## **MANDATORY BULLETIN No. SD-1/003 a**

**Concerning:** Airplanes with rear installation of Magnum 300 rescue system

**Subject:** Reinforcement of rocket holding bulkhead

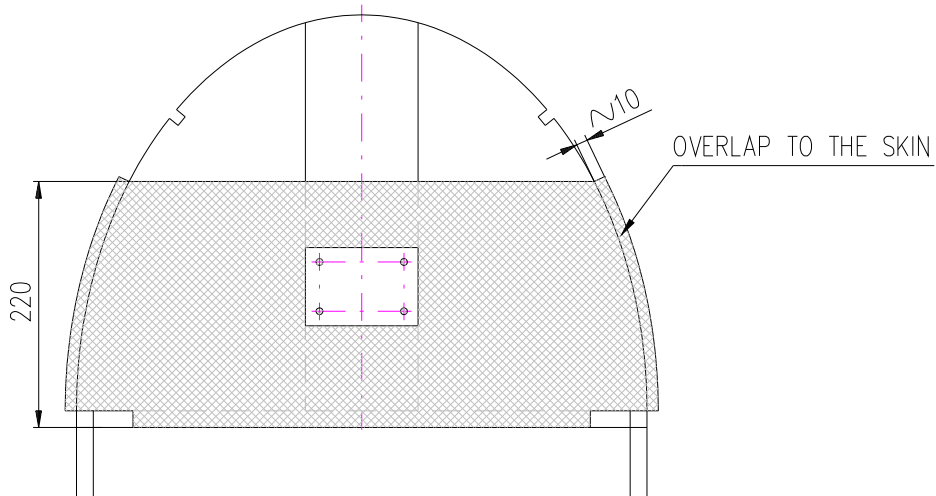
**Reason:** The necessity of rocket holding bulkhead reinforcement was found out after accident rescue system activation

**Necessary material:** Carbon cloth 200 g/m<sup>2</sup> -530x230 –diagonal cut, Resin MGS L 285 +H286

1. Secure rocket activation handle
2. Disconnect rocket cable from parachute.
3. Dismantle rocket from the bulkhead and lay it down onto fuselage floor
4. Dismantle shoulder harness
5. Sand varnished structure in accordance to scheme and clean dust

6. Make lay up of 1 layer C200 diagonally

7. Trim excessive layup after cure. Clean fuselage and reinstall shoulder harness and rocket.
8. Connect rocket cable to parachute and secure it on rocket case using thin nylon cable tie in accordance to picture
